# 产品问题反馈 Product Feedback

»» 项目编号-Project NO. : UN20177

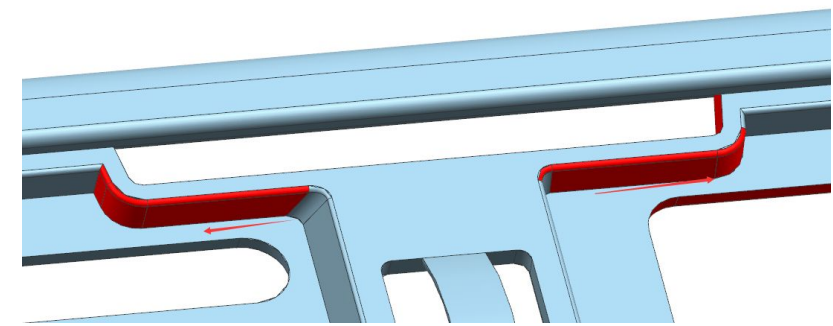
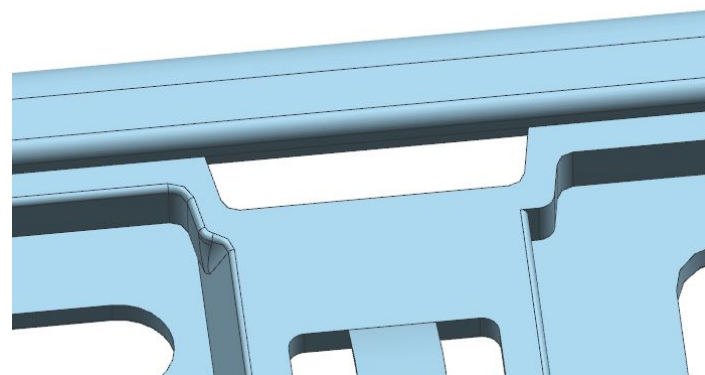
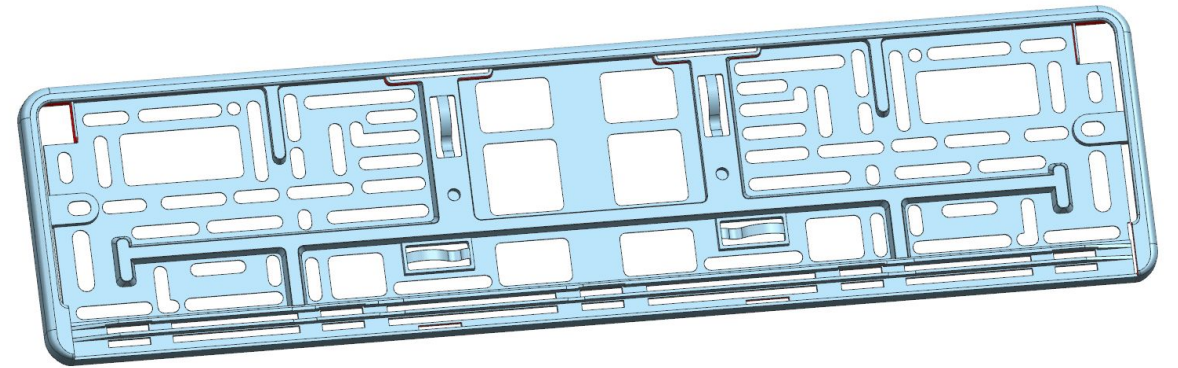
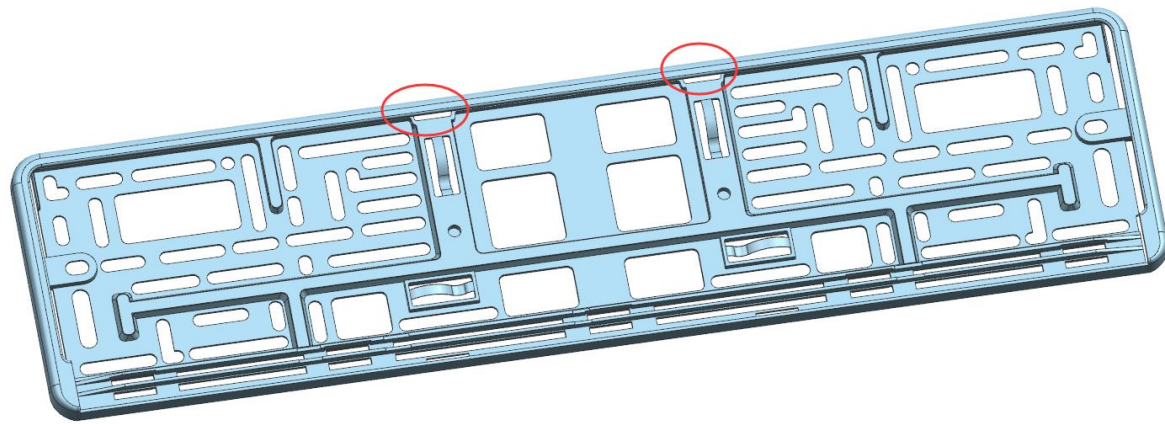
如图, 孔每边加大15mm  
Can we make Hole length longer by 15mm on both sides ?

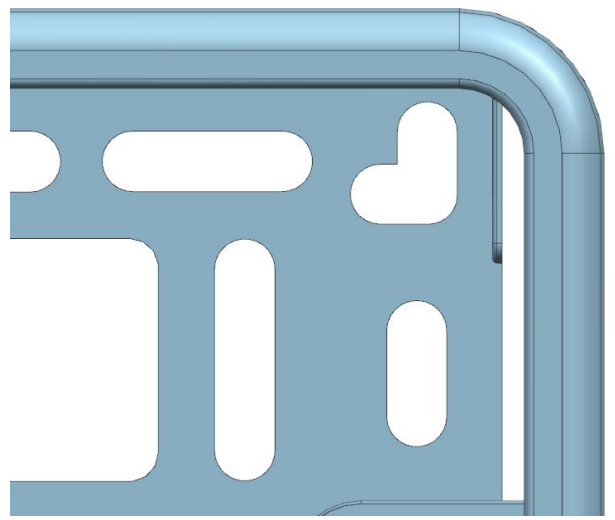
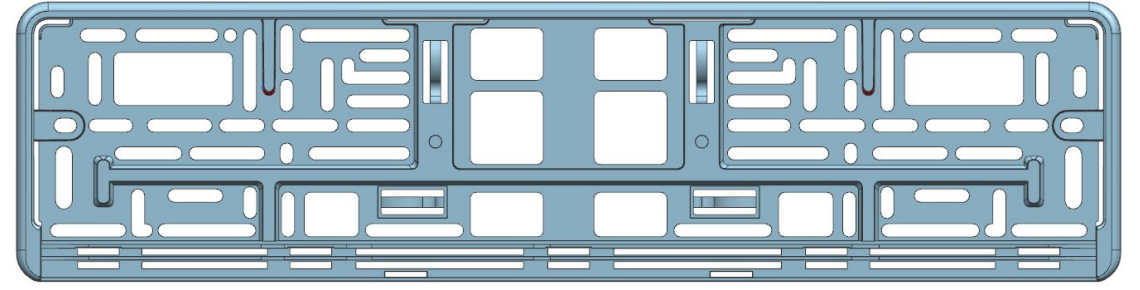
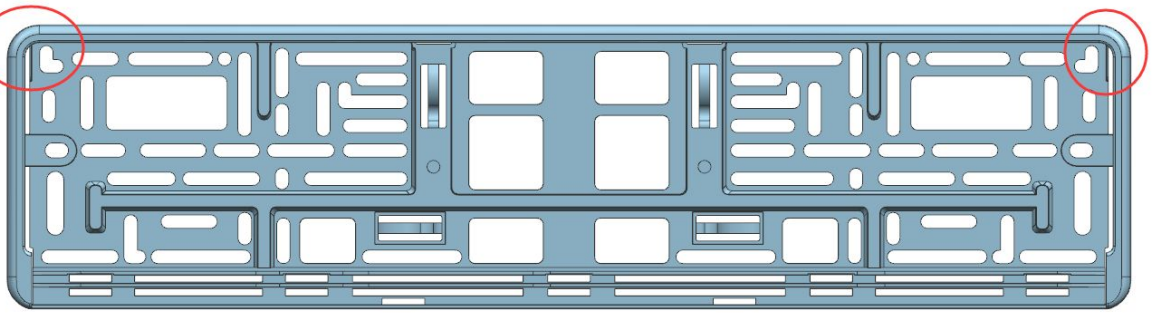
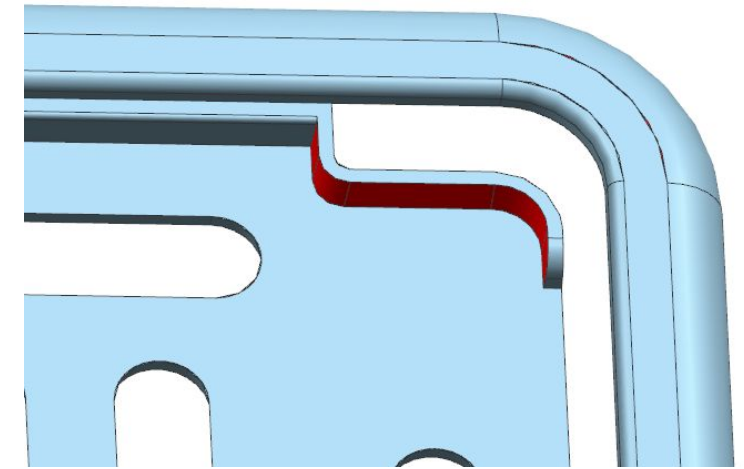
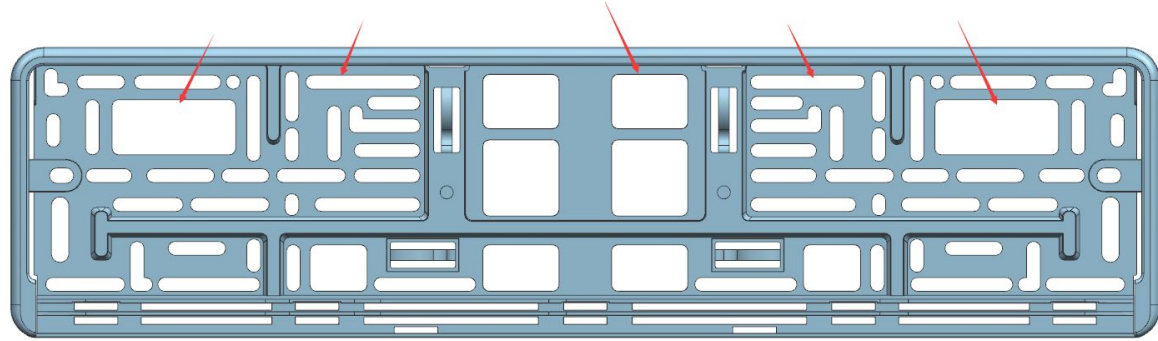
如图, 筋位改变  
Can we make change on rib design

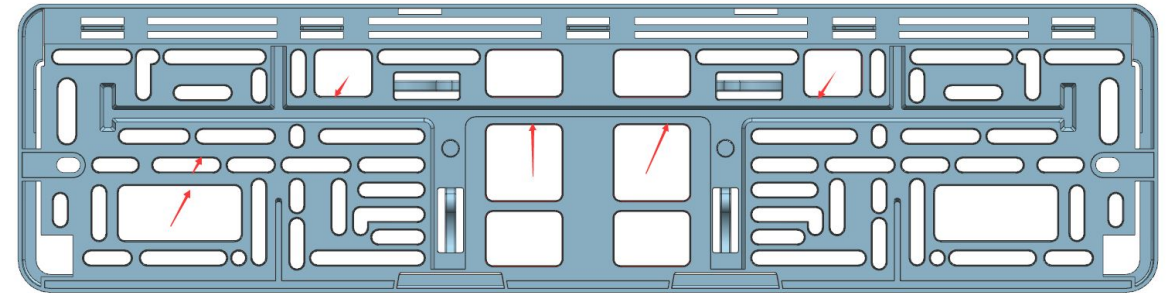
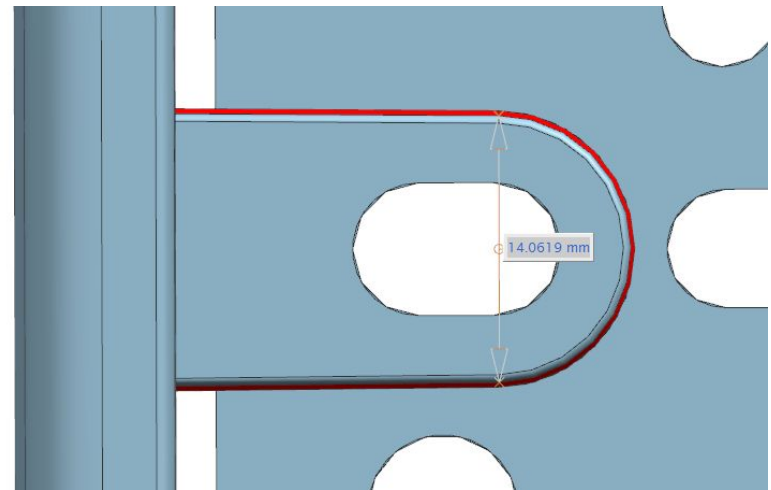
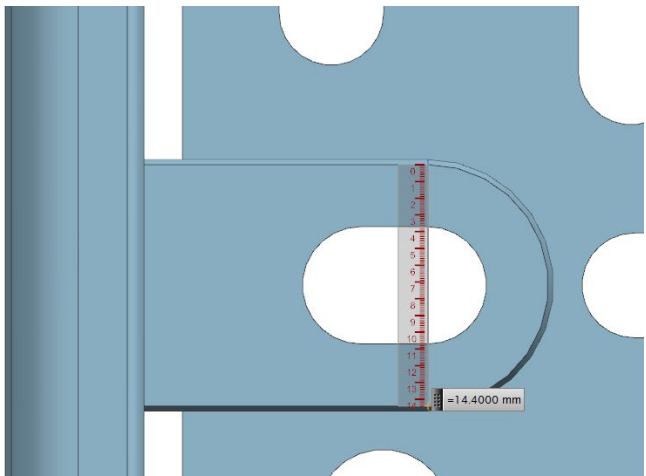
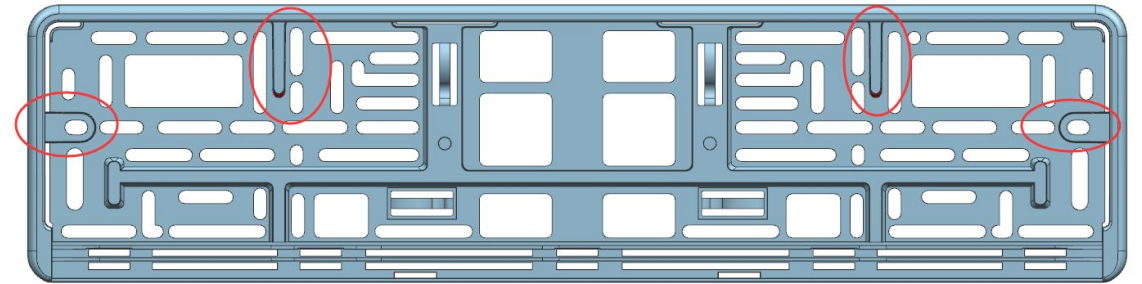
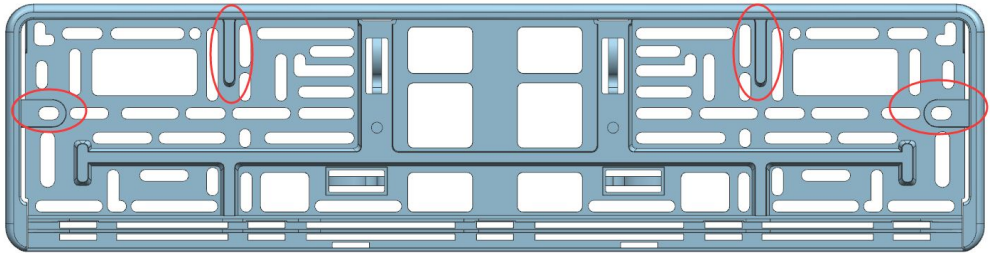
如图, 类似的孔, 斜度加大到10度  
Can we make hole angle to 10 degree

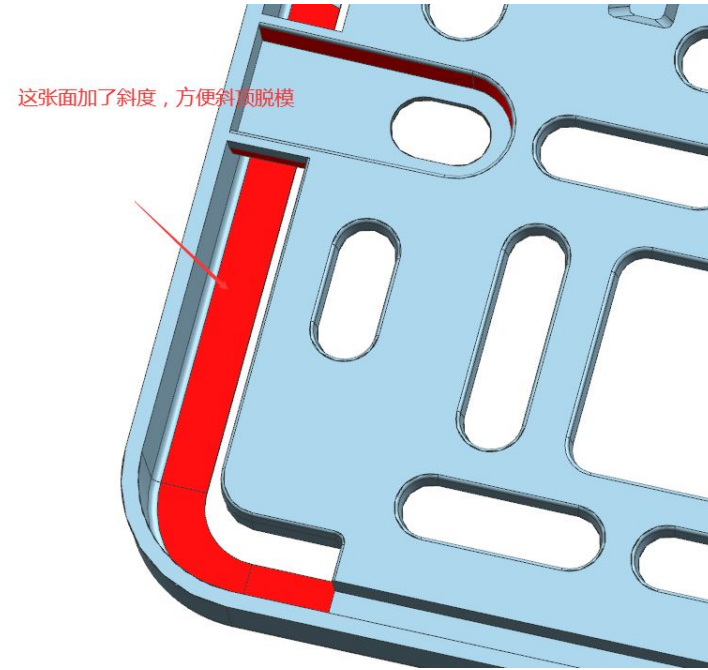
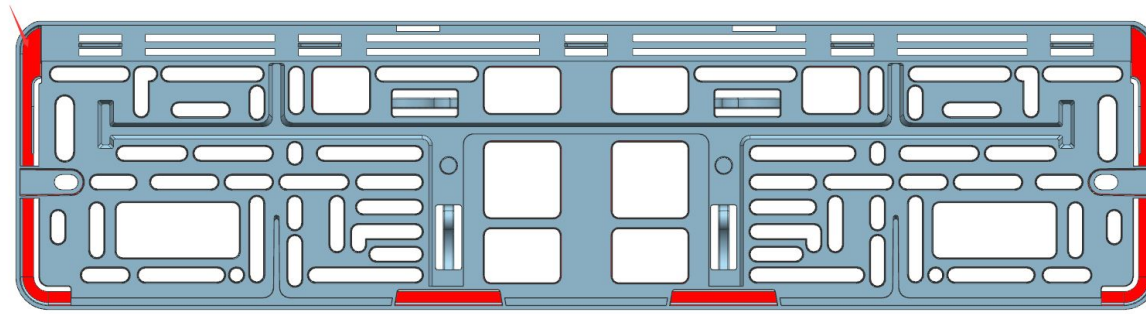
如图4个形状头部缩小单边0.2mm方便脱模

Can we reduce by 0.2mm on every side, it will be easier for mold ejection
